File 1991-0047

Name: Ptarmigan Ridge - Filing 2 - Final Plat

REVIEW COMMENTS

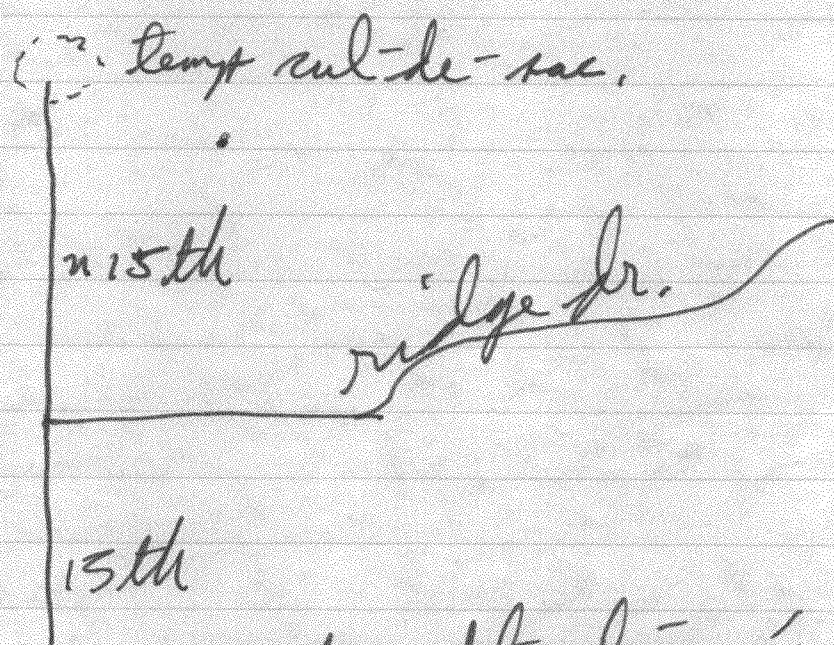
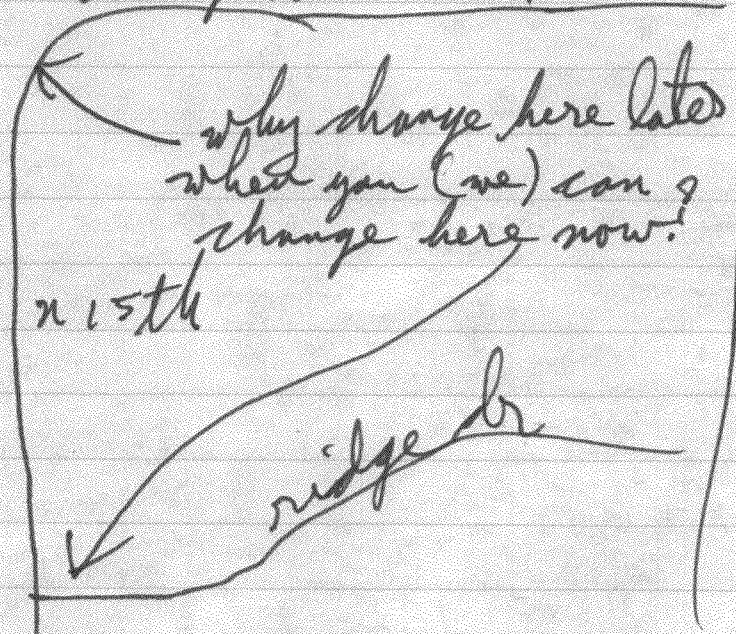
Why a 20 MPH sign on Ptarmigan Ridge Road ?

The name Ptarmigan Ridge Road is very much a part of defining a neighborhood with the attendant sense of pride and cohesiveness, which to me, seems sorely lacking in the suggested generic naming of 15th Street. 15th Street will have to turn east eventually and lose its name (it already does now at Ridge Drive). Why not change the name now and allow the Ptarmigan neighborhood to have this singular street identity. See my attached drawing!

why change here later  
 when you (we) can  
 change here now?

name changed to glaymyn  
 ridge dr on east/west axis 27 1/2

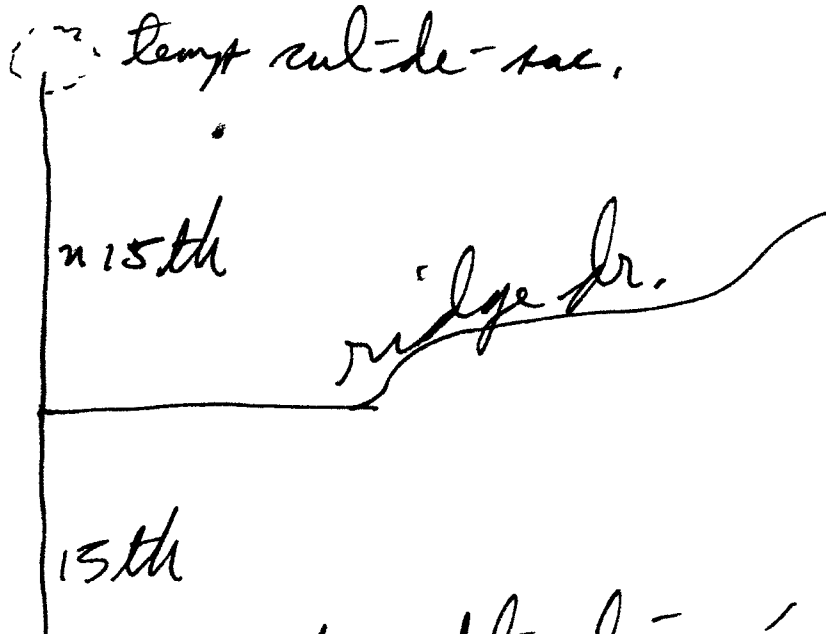
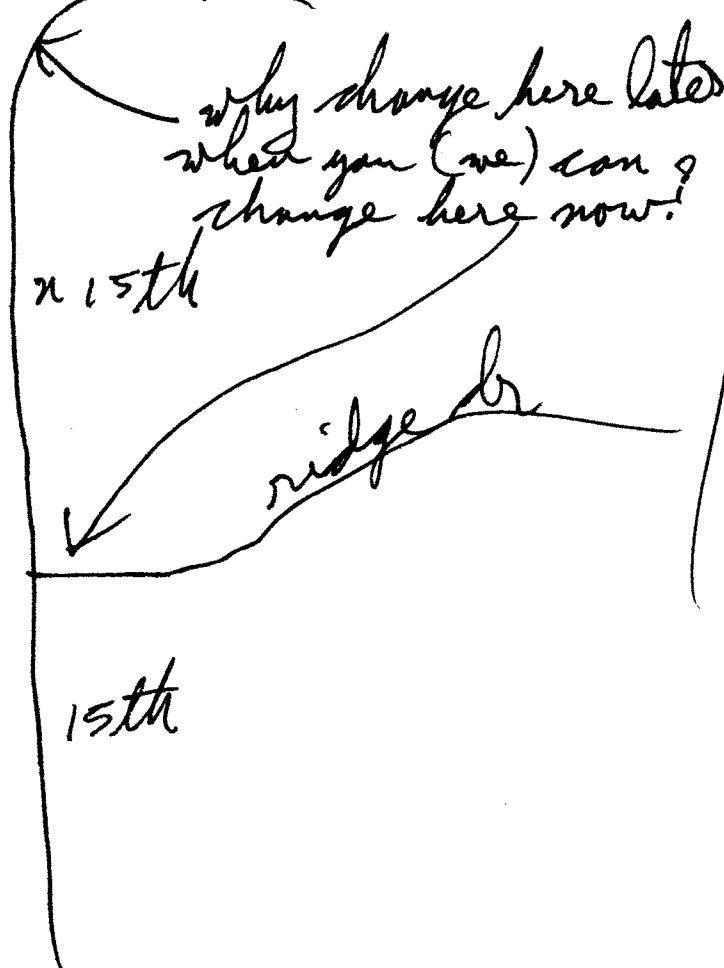
and preserve  
our sense of  
neighbor.

name changed to playing field  
ridge rd on east/west axis  $27\frac{1}{2}$
